<b>MEETING:</b>	<b>PLANNING AND REGULATORY COMMITTEE</b>
<b>DATE:</b>	<b>1 MAY 2024</b>
<b>TITLE OF REPORT:</b>	<p><b>233009 - PROVISION OF A TRANSPORT HUB AND PUBLIC REALM IMPROVEMENTS AT HEREFORD RAILWAY STATION INCLUDING THE CREATION OF A BUS INTERCHANGE, WAITING AREA, CANOPY AND LAYOVER SPACE, PROVISION OF PASSENGER DROP- OFF AND PARKING AREAS, AND FORMATION OF A NEW ACCESS JUNCTION VIA CITY LINK ROAD. AT HEREFORD RAILWAY STATION, STATION APPROACH, HEREFORD, HEREFORDSHIRE, HR1 1BB</b></p> <p><b>For: Mr Butterworth per Mr Luqmaan Kholwadia, 63 St Thomas Street, Bristol, BS1 6JZ</b></p>
<b>WEBSITE LINK:</b>	<a href="https://www.herefordshire.gov.uk/info/200142/planning_services/planning_application_search/details?id=233009&amp;search-term=233009">https://www.herefordshire.gov.uk/info/200142/planning_services/planning_application_search/details?id=233009&amp;search-term=233009</a>
<b>Reason Application submitted to Committee – Council Application</b>

**Date Received: 10 October 2023**

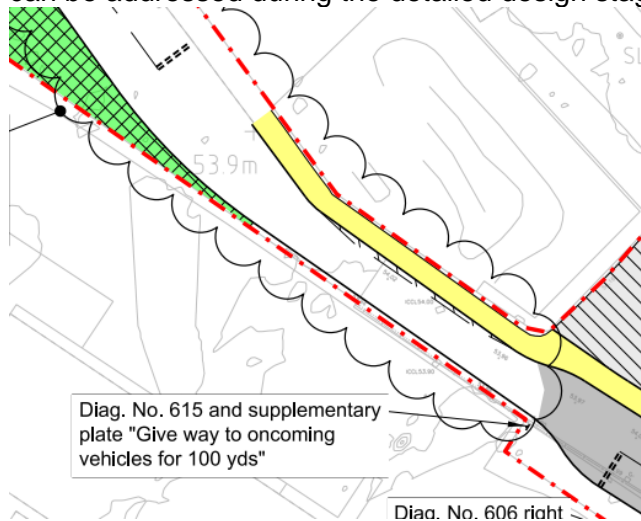
2. Visibility splays have been demonstrated on submitted plans, however, the splay for the access into the Bus Layover has not been provided. This should be demonstrated on a plan. In addition, the junction immediately north of the Bus Layover with the access road to MFA Bowl as well as the staff car park and the DIRO bays has not been provided with sufficient visibility splays. The splays should measure 2.4m x 43.

4. There are too many manoeuvres on the plan demonstrating the swept path analysis of a coach using the DIRO bays. Would it be possible to be provided with the CAD version of the plan please to understand the manoeuvres properly? From looking at the mass of manoeuvres shown there is an area of dead space which should be removed (shown in yellow on screenshot below). It was also agreed during pre-app discussions that due to the access road only be used by the buses using the DIRO bays that the access road could be used for reversing manoeuvres but the tracking indicates that this isn't utilised to its full extent (although this can be confirmed upon sight of the CAD plan), therefore further redundant dead space may become apparent.

6. During pre-app discussions it was proposed to relocate all of the drop-off bays into the NCP car park and provide a free 15 minutes duration of stay, however, it is noted that a few bays have been provided in the area immediately in front of the station entrance. Without seeing the car parking/drop-off survey undertaken it is difficult to understand what level of drop-off provision is required. If enough isn't provided in front of the station entrance this could result in vehicles driving into the drop-off area, not finding a space to park and just stopping in the carriageway and blocking the road for others and causing a queue back out onto Station Approach. The survey data should be provided in order to establish whether the spaces provided are enough or whether all drop-off should be provided in the NCP car park.

7. Junction modelling has been undertaken and the results show that all junctions operate well within capacity. The PICADY/LINSIG outputs have not been included within the TA for checking, these should be provided. Concern was raised by both the LHA and the RSA Auditors about buses turning right out of the exit only junction by the DIRO bays onto the City Link Road and whether capacity/traffic flows would allow this manoeuvre to be undertaken relatively easily. The modelling undertaken indicates that this will not be an issue, although it would be advisable for yellow box junction markings to be put on the City Link Road at the junction to ensure queuing does not prevent buses from turning out onto the City Link Road at peak times.

8. Cycle parking is to be provided throughout the site. There will be a small element of covered cycle parking, however, the majority is to be uncovered. Ideally all cycle parking would be covered, however, following discussions it is understood that most cycle parking is uncovered so as not to impact on the heritage status of the station building, therefore the LHA is accepting of the position regarding covered cycle parking.

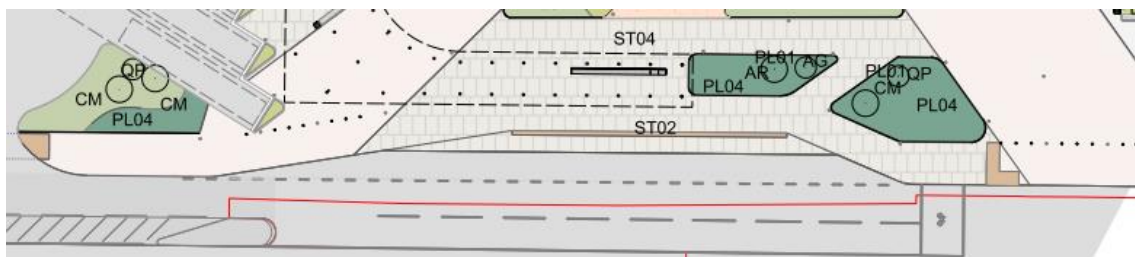
- There is a need to protect the visibility splay highlighted in yellow in screenshot below – a solution could be to define the splay with a fence to ensure it isn't encroached upon. This can form a condition of planning consent should it be granted.

- The hatching within the narrowing should be kerbed to ensure two-way movement is prevented. The tracking for a coach demonstrates that the hatched area isn't needed. This can be addressed during the detailed design stage.

- Cycleway – To clarify, the preference is for a 3.5m machine laid tarmac unsegregated route consistent with the existing route and delineated at rear with an edging kerb. The proposed variety of surfaces as shown below is not considered to be acceptable and will confuse cyclists, it is also not consistent with the requirements of LTN1/20. The type of surfacing of the cycleway could form a condition of planning consent should it be granted.

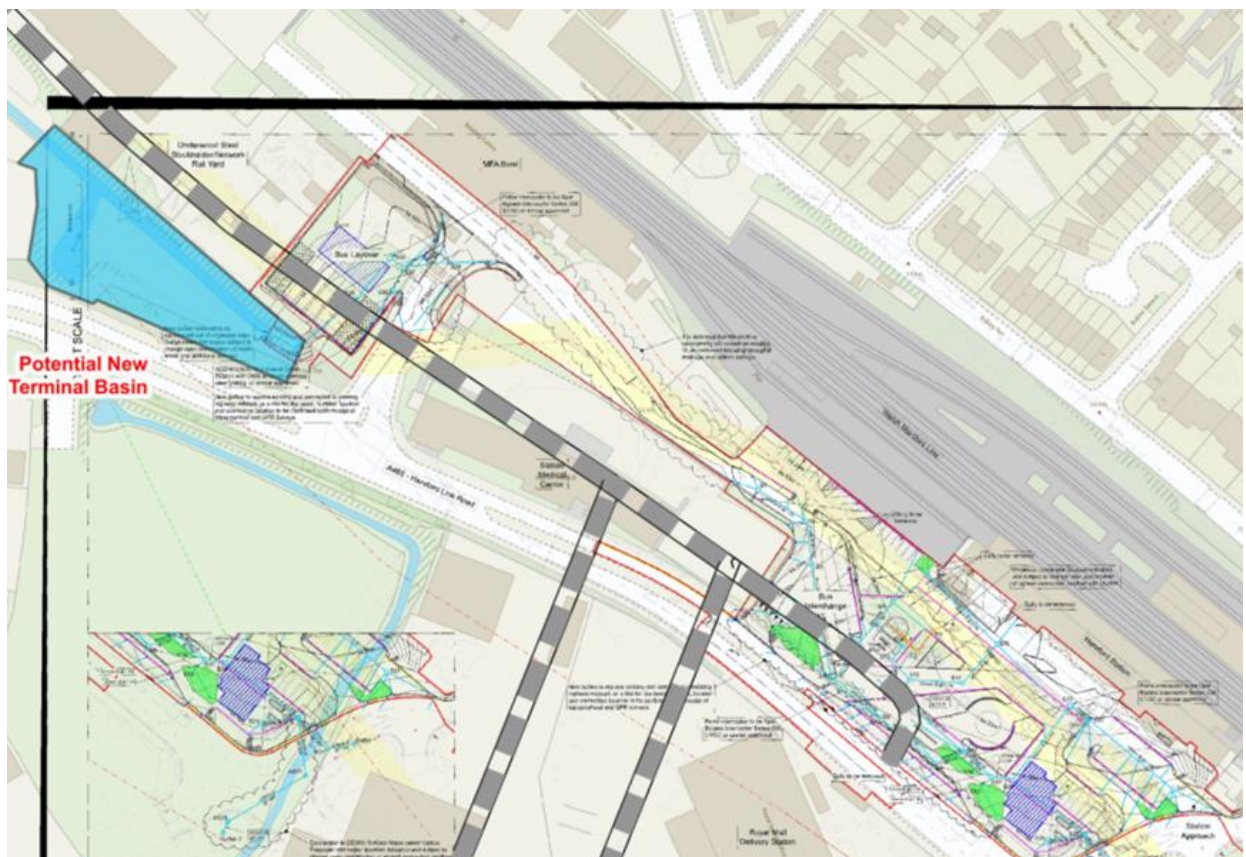
5. The plans show Network Rail parking remaining in its current location, with access and egress being off City Link Road to the north of the medical centre (ref Movement Strategy dwg 00105). Anyone grounded in reality knows that NR staff will be tempted to avoid the chicane and take the direct exit via the DIRO area. They may even be tempted to enter by the same route. This is a serious flaw in the layout which should have been identified and eliminated early in the design process. A prerequisite of safe DIRO operation is that only buses and coaches can enter the reversing area and all other vehicles are physically prevented from doing so (by an automatic barrier or rising bollard).

6. At the northern end of the current NR parking is a gateway in the fence which is used by Road Rail Vehicles to access the track. HGV's delivering/collecting RRV's will be unable to access the car park due to the restrictive kerb layout and they will create a serious obstruction if they park on the access road.

7. The bus layover area is remote from the Hub and any bus accessing it between services will have to negotiate two City Link Road junctions to do so. On Wednesday six Market Day services need long layover and only five spaces have been provided. Its capacity would appear inadequate, and once the Country Bus Station has gone there will be no alternative.

The proposal's serious shortcomings outlined in points 5), 6) and 7) above could perhaps be partially overcome by purchasing the disused Crazy Golf course within the curtilage of MFA Bowl. As the Design and Access Statement confirms that the NCP car park is underutilised, surely the NR parking could be moved within it as it would be no further from the station building. This car park already has several dedicated spaces for the signalmen and these do not seem to be abused

by the public. That done, the access road behind the SMC could become two-lane one-way and drop off/layover provided throughout its length.
